Los Angeles Regional Water Quality Control Board

SUBJECT: REVIEW OF DRAFT REMEDIAL ACTION PLAN; CLEANUP AND ABATEMENT ORDER NO. R4-2021-0079 AMENDMENT

SITE: SKYPARK COMMERCIAL PROPERTIES (ASSESSOR PARCEL NO. 7377-006-906), 24701 – 24777 CRENSHAW BOULEVARD AND 2530, 2540, AND 2600 SKYPARK DRIVE, TORRANCE, CALIFORNIA (SCP NO. 1499, GLOBAL ID NO. T10000014333)

Attachment 3 - Figure 20 – Proposed Soil Vapor Probe Locations

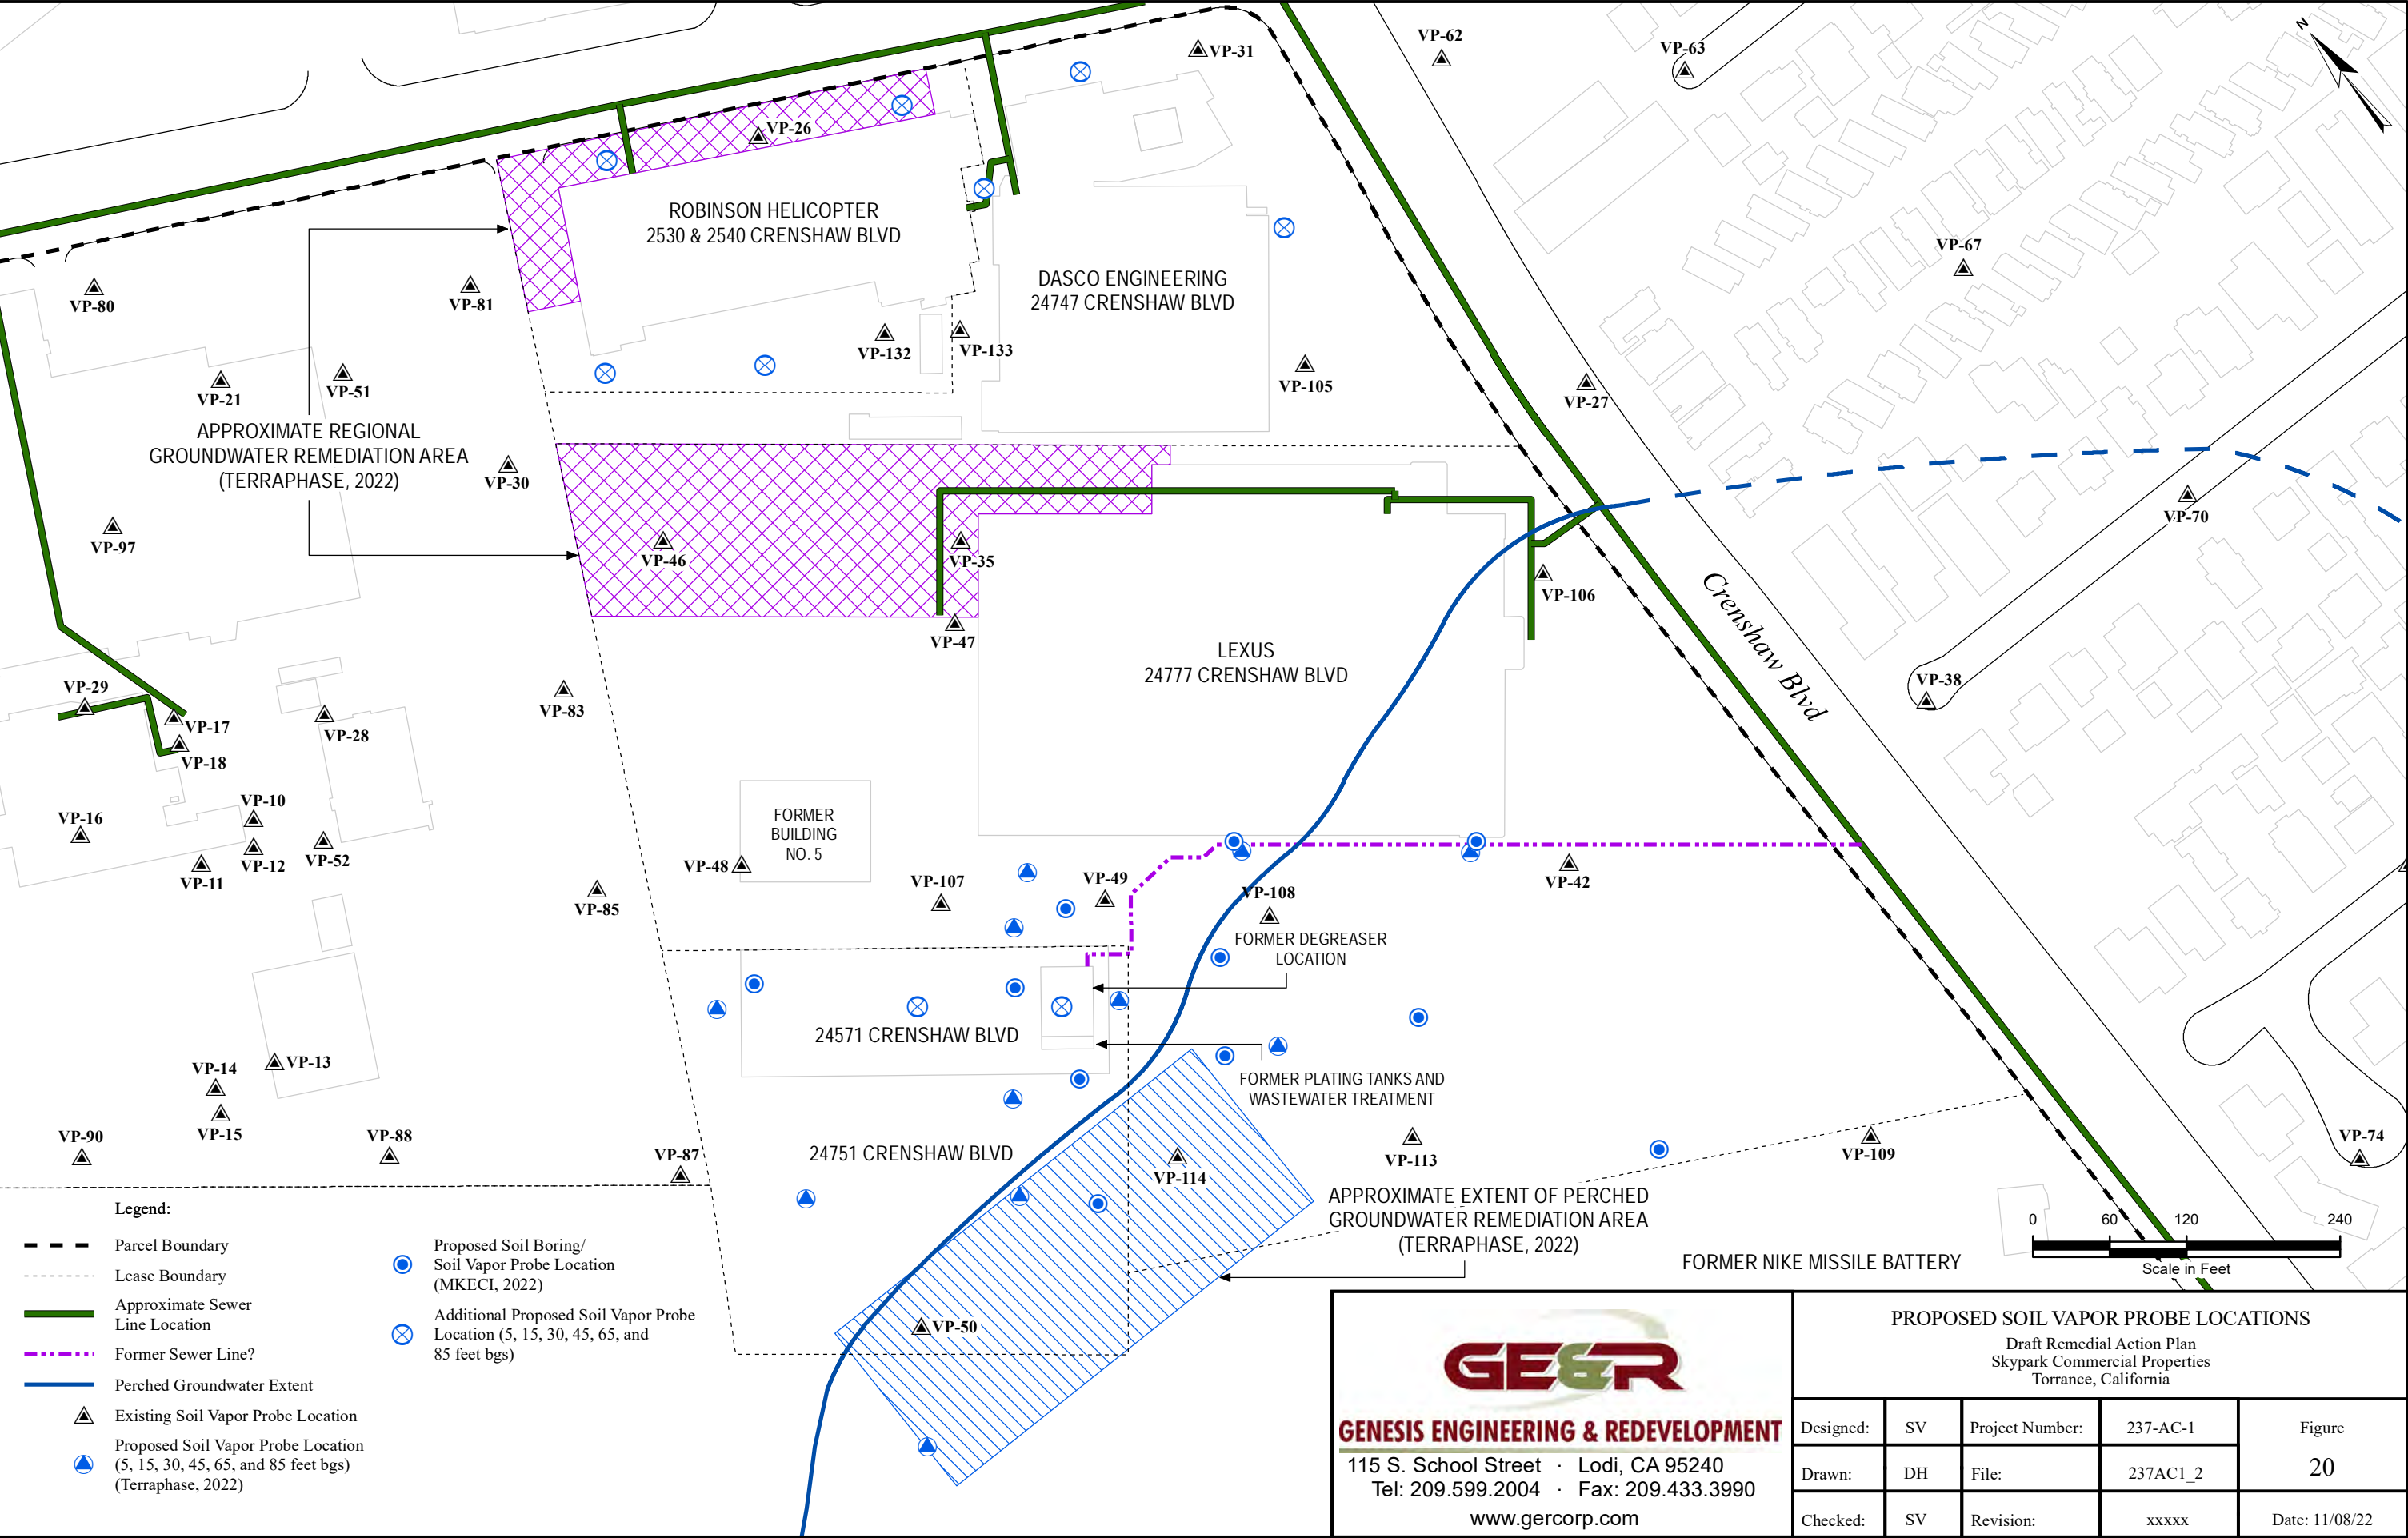
- c. Incorporate perched groundwater monitoring wells into the groundwater monitoring program.
2. Soil vapor beneath the EA Properties.
 - a. Advance two borings and install soil vapor probes at 5, 15, 30, 45, 65, and 85 ft-bgs inside the unoccupied building on Property 1 of the EA Properties, as shown in Attachment 3, *Figure 20 – Proposed Soil Vapor Probe Locations* (Figure 20). These borings are in addition to the investigative component of the Revised EAP IRAP conditionally approved by the Los Angeles Water Board on July 27, 2022.

- b. Advance seven borings and install soil vapor probes at 5, 15, 30, 45, 65, and 85 ft-bgs on Properties 2 and 3 of the EA Properties, as shown in Figure 20.

6. The Los Angeles Water Board conditionally approves the scope of work to assess soil vapor beneath the EA Properties, as shown in Figure 20, with the following comments and requirements:

- a. Los Angeles Water Board staff is concerned about the potential continued source(s) in the vicinity of groundwater monitoring well MW-8 on Property 3 of EA Properties. Recent PCE groundwater concentrations at MW-8 were detected up to two orders of magnitude greater than its maximum contaminant level (MCL). Recent TCE groundwater concentrations at MW-8 were detected more than three orders of magnitude greater than its MCL. These recent elevated PCE and TCE groundwater concentrations indicate rebounding to nearly pre-2017 EISB injection levels at the HSC property.

- b. Soil samples shall be collected at 5-foot intervals to total depth and screened for VOCs using a photo ionization detector (PID). Soil samples from the proposed soil vapor probe depths (i.e., 5, 15, 30, 45, 65, and 85 ft-bgs) shall be submitted for laboratory analysis of VOCs. In addition, soil samples at any depth interval that exhibit PID readings or visual staining shall also be submitted for laboratory analysis of VOCs.

- c. Note that the Site has been experiencing local rising groundwater levels. Soil vapor probes that cannot be installed at 85 ft-bgs shall be installed above the existing water table or at 75 ft-bgs (to be consistent with the conditionally approved *Revised Off-Site Assessment Work Plan* dated August 5, 2022 [i.e., assessment of the south-southwestern, north-northwestern, and western extents of VOC impacts to soil vapor on and in vicinity of the Lowe's Property]) to prolong accessibility and life spans of the soil vapor probes.

Attachment 4 - Figure 22 – Proposed Soil Vapor Probes Beneath the Perched Groundwater Zone Beneath the EA Properties

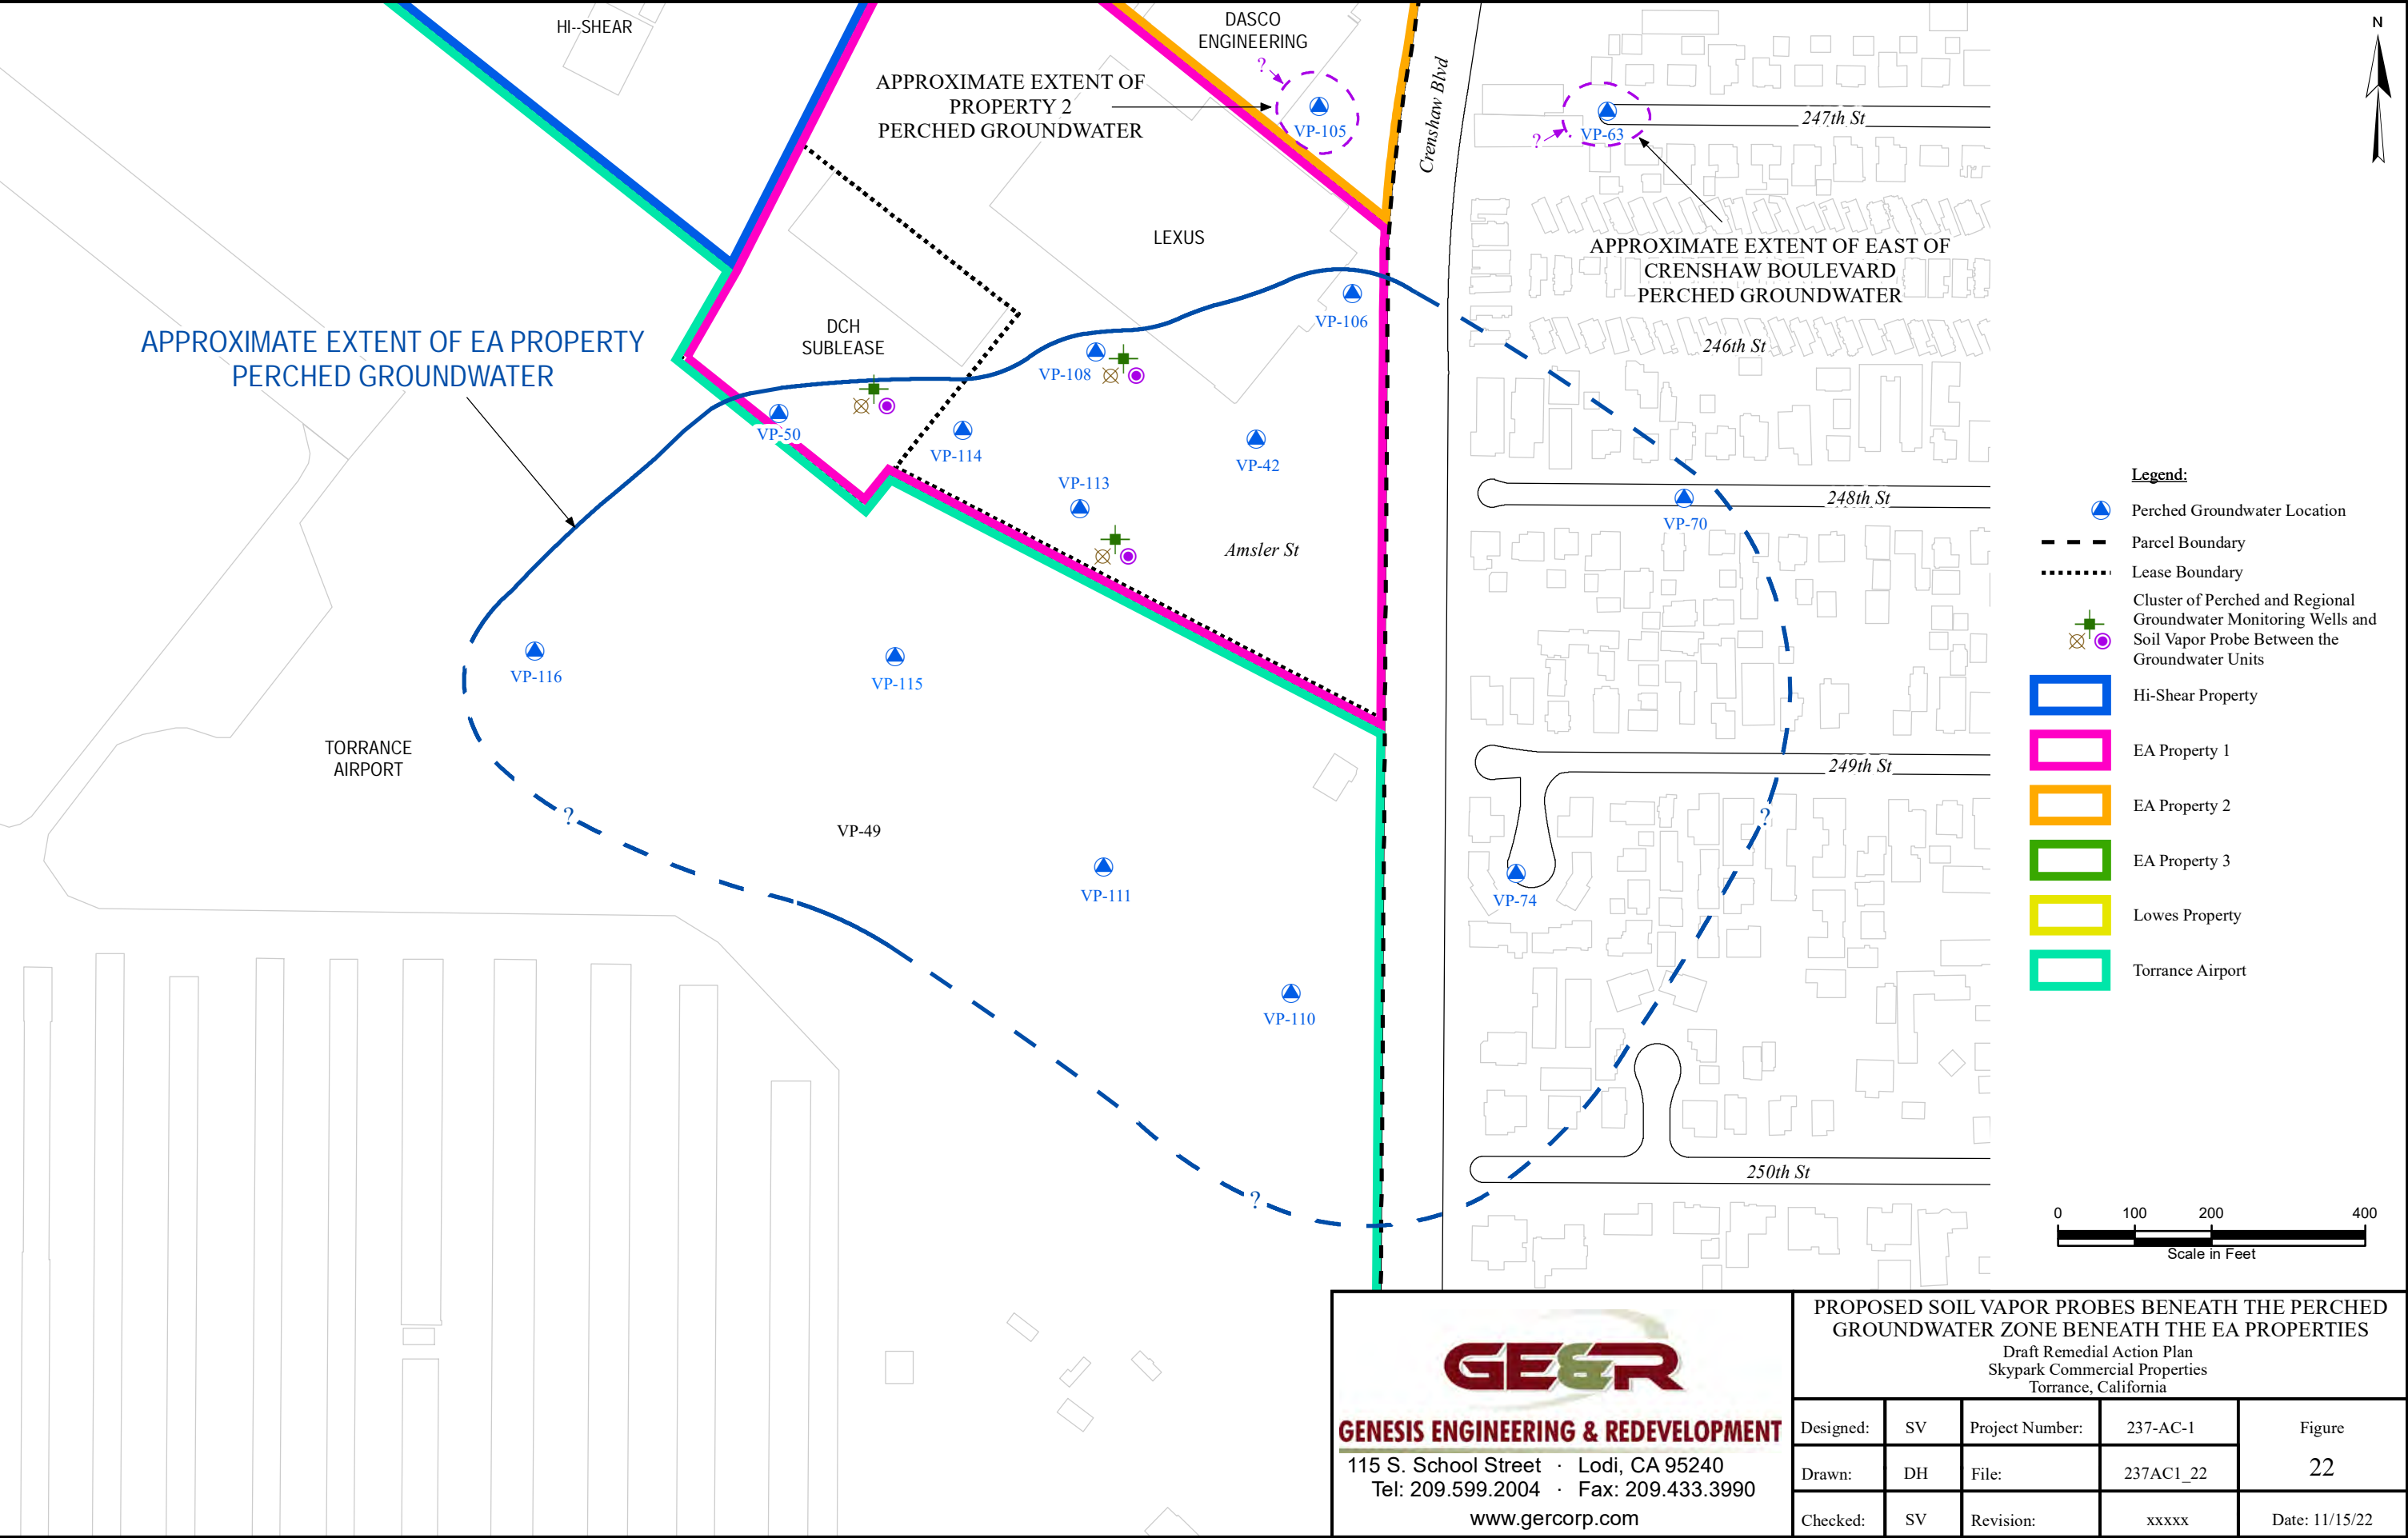
3. Soil vapor between the perched and regional groundwater beneath EA Properties and Torrance Airport.
 - a. Advance three borings to beneath the perched groundwater and above the regional groundwater and pair with triple-nested groundwater monitoring wells, as shown in Attachment 4, *Figure 22 - Proposed Soil Vapor Probes Beneath the Perched Groundwater Zone Beneath the EA Properties* (Figure 22). Install soil vapor probes at 80 ft-bgs.

7. The proposed scope of work to assess soil vapor between the perched and regional groundwater beneath EA Properties and Torrance Airport, as shown in Figure 22, is approved. Submit a report, at a minimum documenting the results of the soil vapor assessment, field observations, laboratory data, conclusions, and recommendations. Task 3.a. – Site Assessment (i.e., vertical and lateral delineation) of the Order is the underlying requirement of this proposed scope of work.
